**TW Billing: mowing, brush clearance
and wetland clearance**

| DESIGNED BY VVF | Great Kills Park, Staten Island, NY | Figure # |
| CHECKED BY CO | Contract No: W92BU-13-C-0010 | January 2014 |

Document Name: SI_TW_Billing_Jan_2014_progress_points_gaps

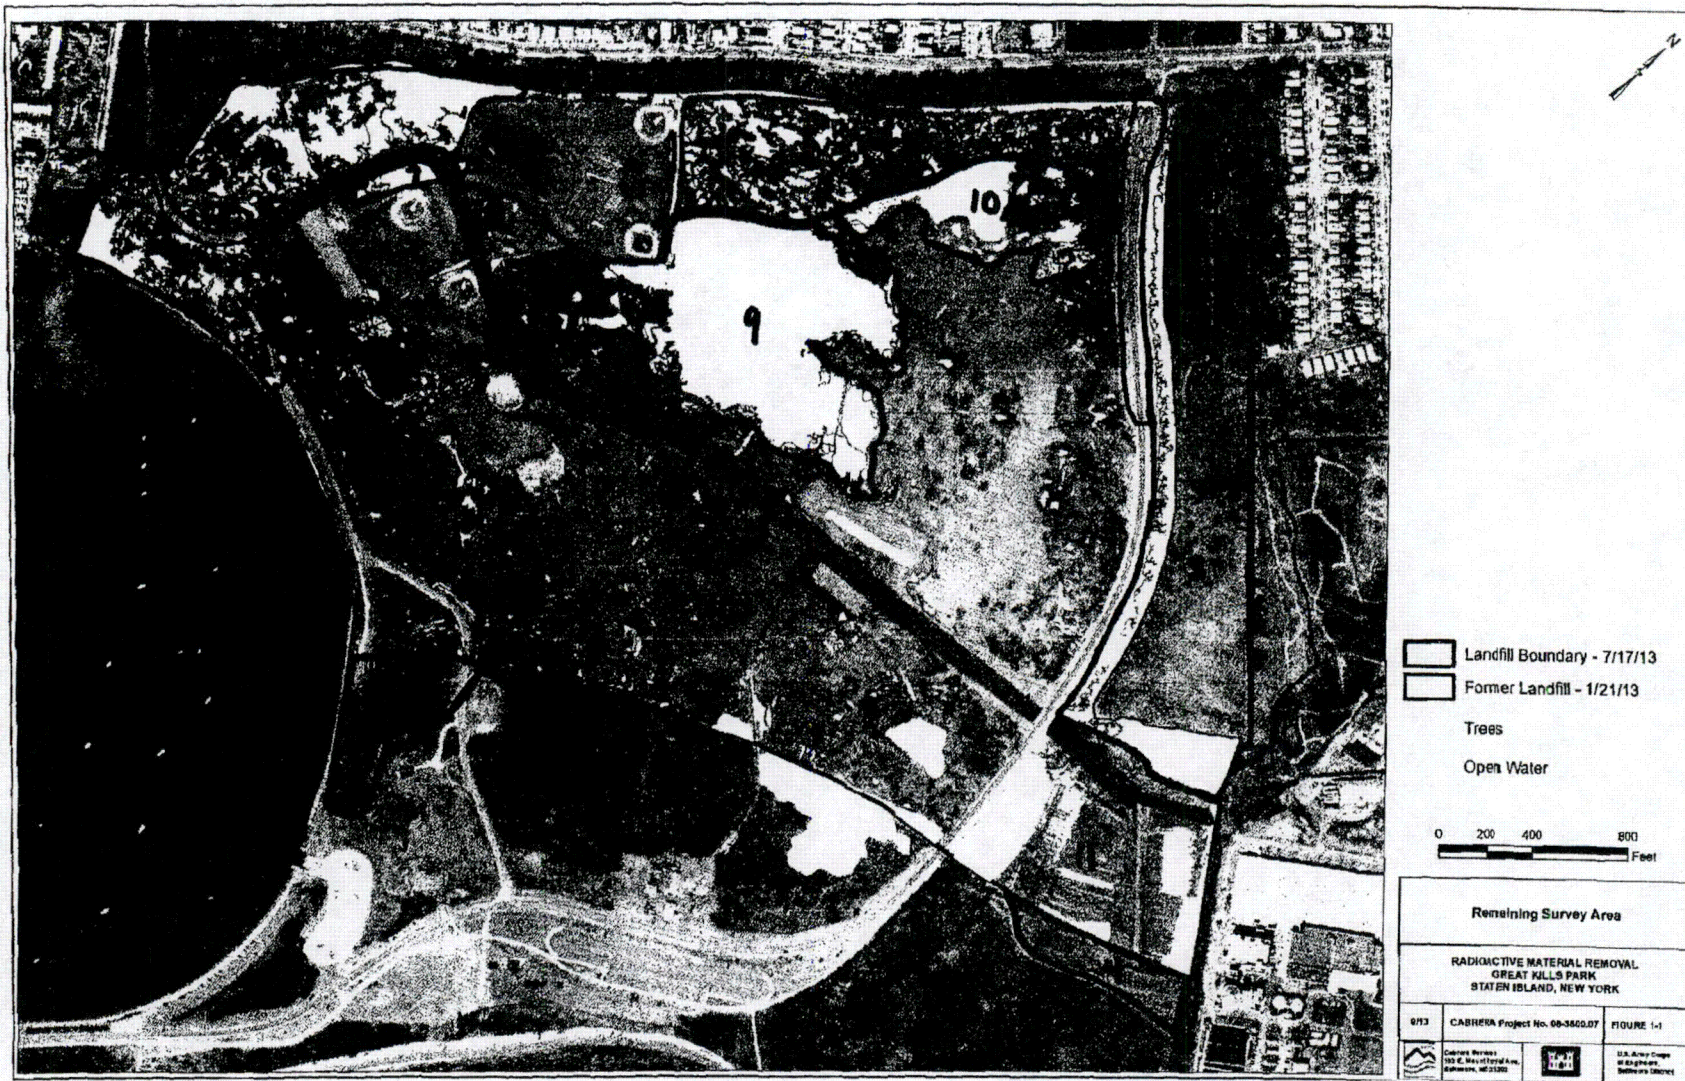
1. AREA 1 Has been cleared. Survey is in Progress.
2. The above mentioned area has been inspected and Verified on 10 January 2014 by USACE Field Representative. Rodolfo Alf.

Areas 2, 9, and 10 are approved GAMMA survey
Rohrbaugh, Co
3/14/2014

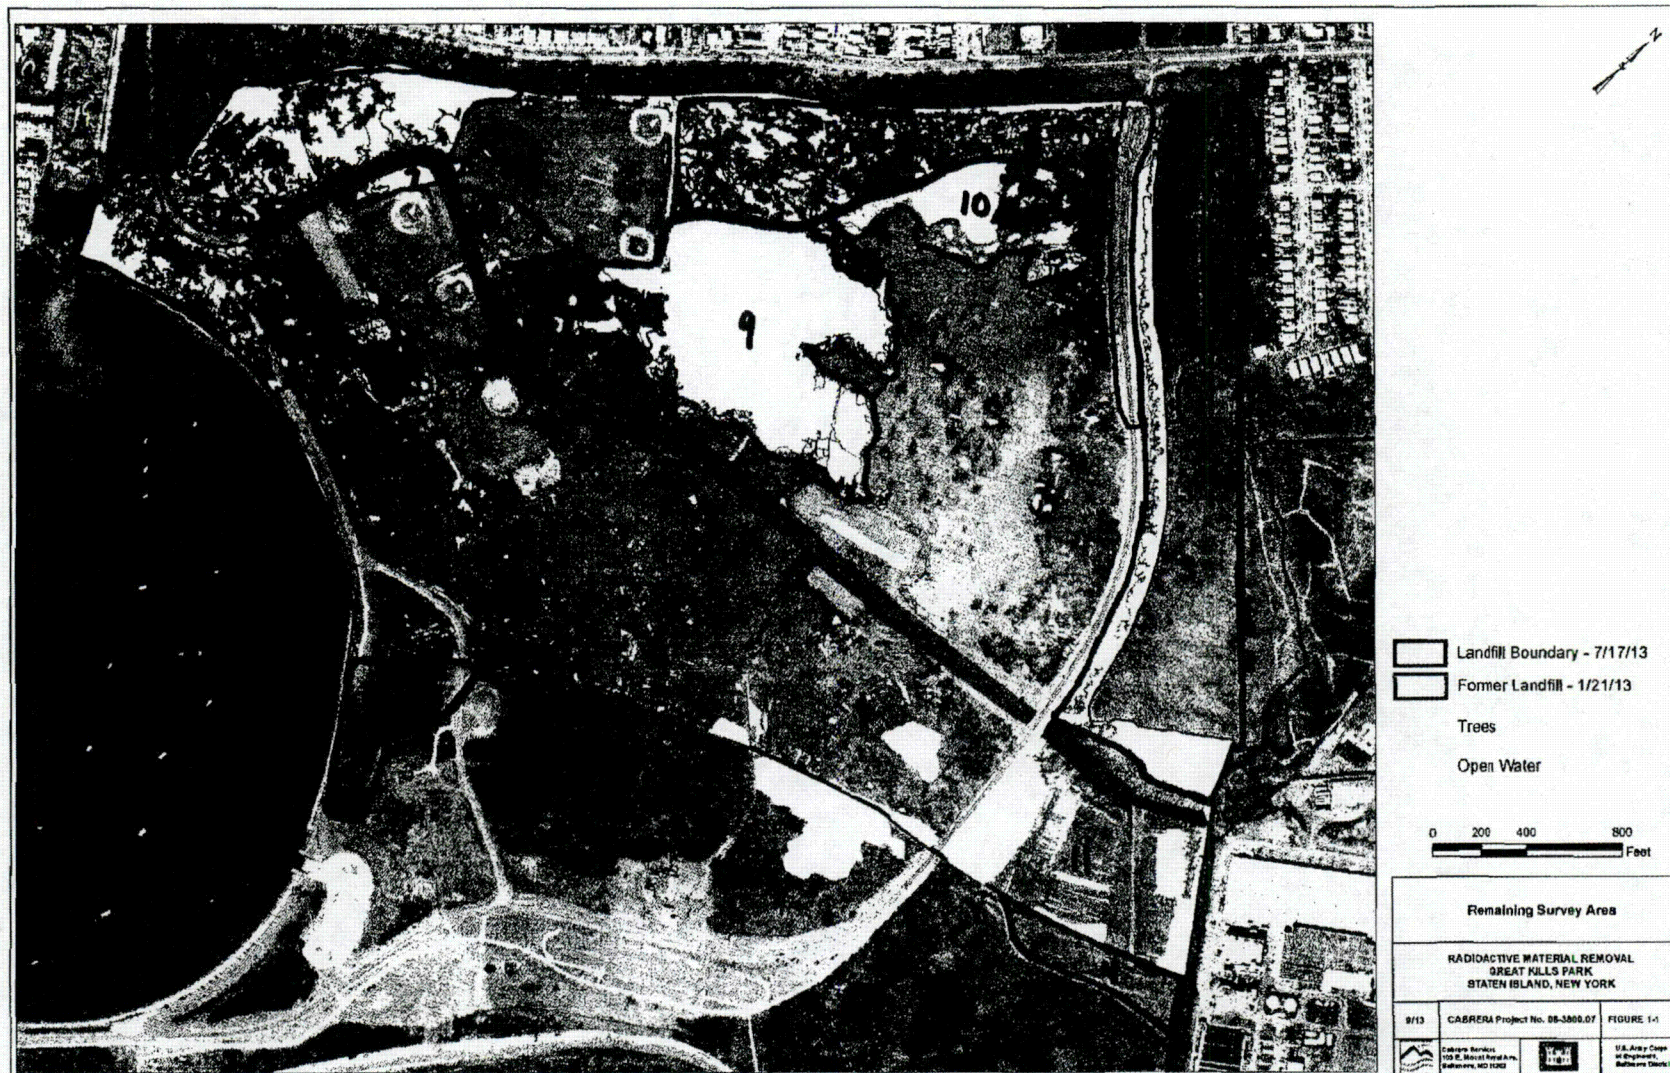
AREA 3 Wetland is APPROVED

For Radioactive Survey

AREAS 5 & 7 have been approved for Gamma Survey.

Resubmit the Noel, COR
Army Corps of Engineers

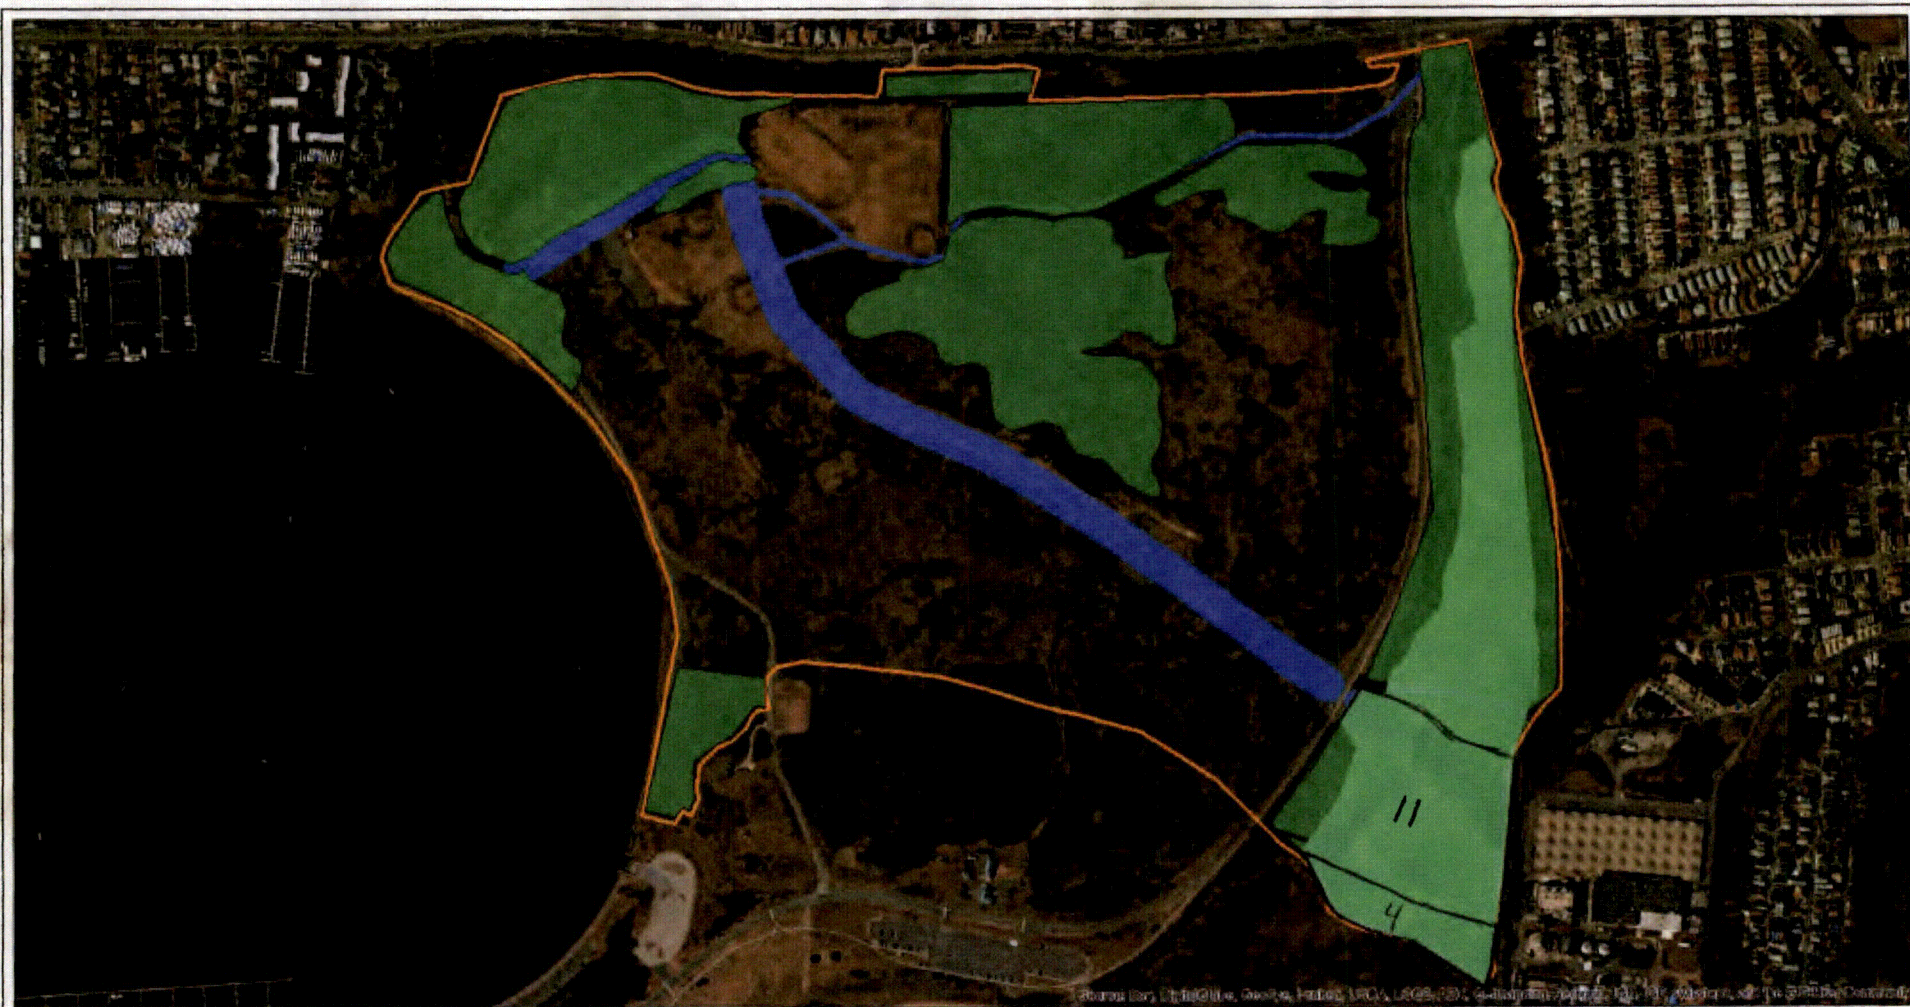
AREA 8 BRUSH CLEARANCE IS APPROVED.
